MEMORANDUM TO PLANNING COMMISSION

DATE: April 21, 2022
FROM: Russ Holley, Senior Planner
SUBJECT: **Altura Resubmittal**

Project #22-019
Altura
Located at approximately 830 W. 2075 S.

Project Name: Altura
Proponent / Owner: Dan Larsen / Strata Land Holdings LLC
Project Address: ~ 830 West 2075 South
Request: Design Review & Subdivision Permit
Current Zoning: Mixed Residential Medium (MR-20)
Type of Action: Quasi-Judicial
Hearing Date: April 28, 2022 (cont. from 4-14-22)
Submitted By: Russ Holley, Senior Planner

April 18, 2022 | MR210700.00

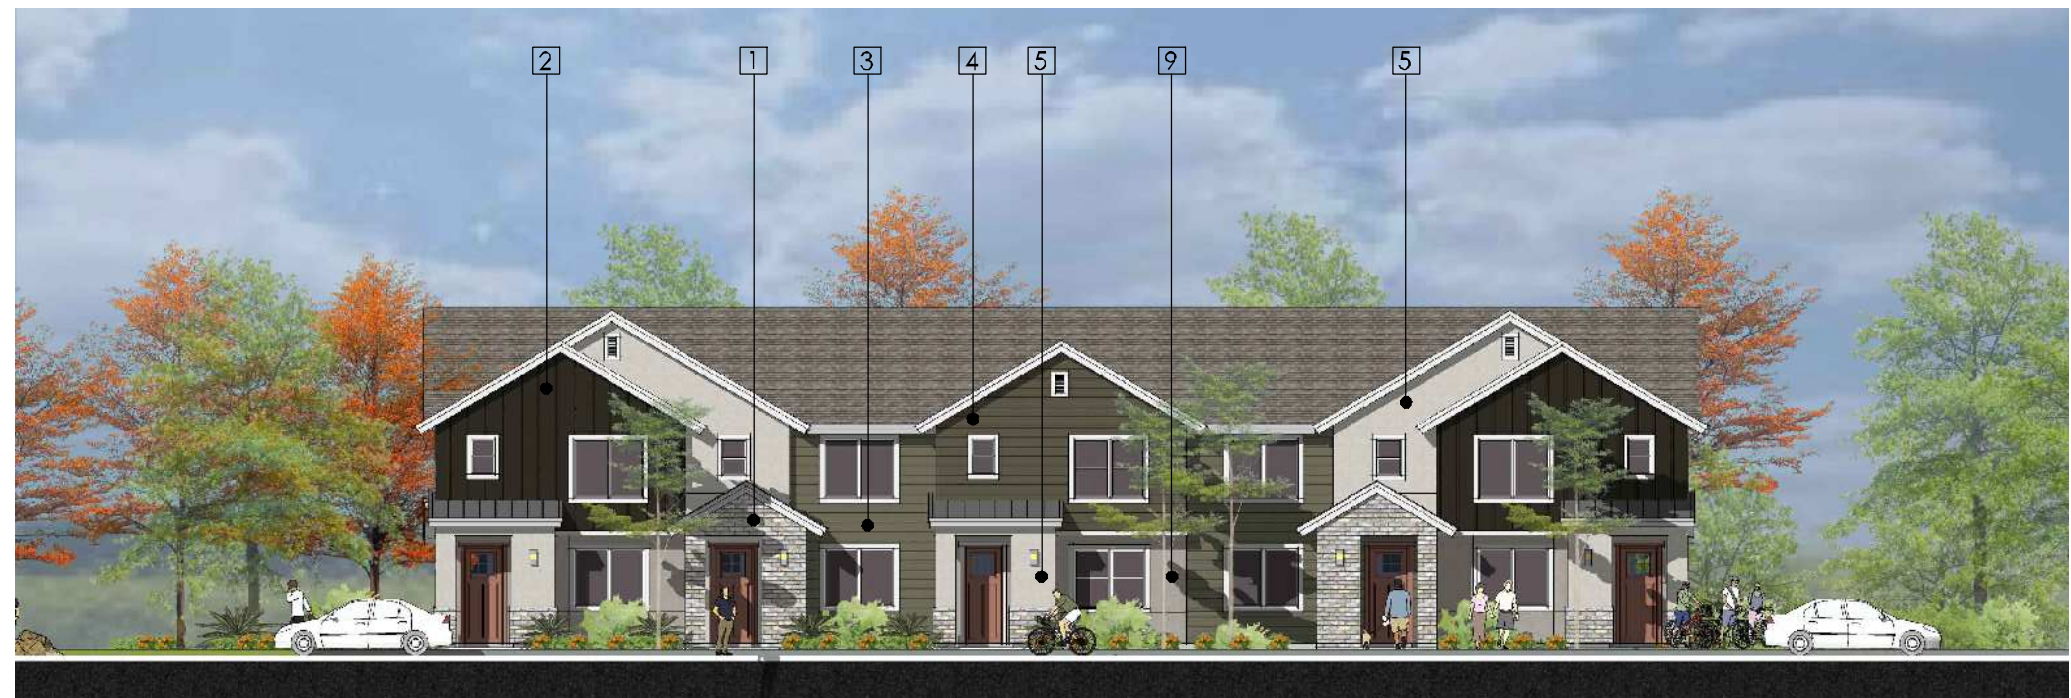
The LDC 17.09.040 states that buildings should be oriented towards the adjacent street or common courtyard with front facades and front doors for visual and walkability reasons. In certain cases, for practicality reasons or unique site constraints, buildings can orient away from the street, but façade considerations (four-sided architecture) and walkability should create inviting architecture and maintain direct walkability. The proposed townhomes all orient to either the street or a common courtyard providing direct pedestrian connections. The 24-plex building all orient to the parking lot areas with rear façades facing the adjacent streets. For other 24-plex projects in the past, a common breezeway through the entire building provided direct pedestrian access to the street, but these building designs do not show that option. One must walk around the building(s) to access the street. This pattern is contrary to the preferred layout and does not place the prominent (most visually pleasing) façade along the street. Rear facades become the most visually prominent façade from the street.

The LDC 17.09.040 requires multi-family buildings to have minimum variations, interesting façade design, a mix of materials and articulation for aesthetically pleasing projects. The MR-20 zones are required to have minimum street-facing façade design variations from adjacent buildings to enhance neighborhood character and create visual interest (limit “cookie-cutter” homes). The LDC identifies eight (8) different categories and requires that at least four (4) out of the eight (8) be noticeably different. The eight (8) categories listed are building color, materials, roofline, height (number of floors), fenestration, architectural style, articulation, and porch design. The proposal shows façade variations with slight adjustments. As conditioned with the Planning Commission determining variation, the project meets the code requirements in the LDC.

1. All standard conditions of approval will be recorded with the Design Review Permit and are available in the Community Development Department.
2. The Planning Commission will determine façade variation for the 24-plex buildings. As shown, the buildings show a minimum of 4 differences.
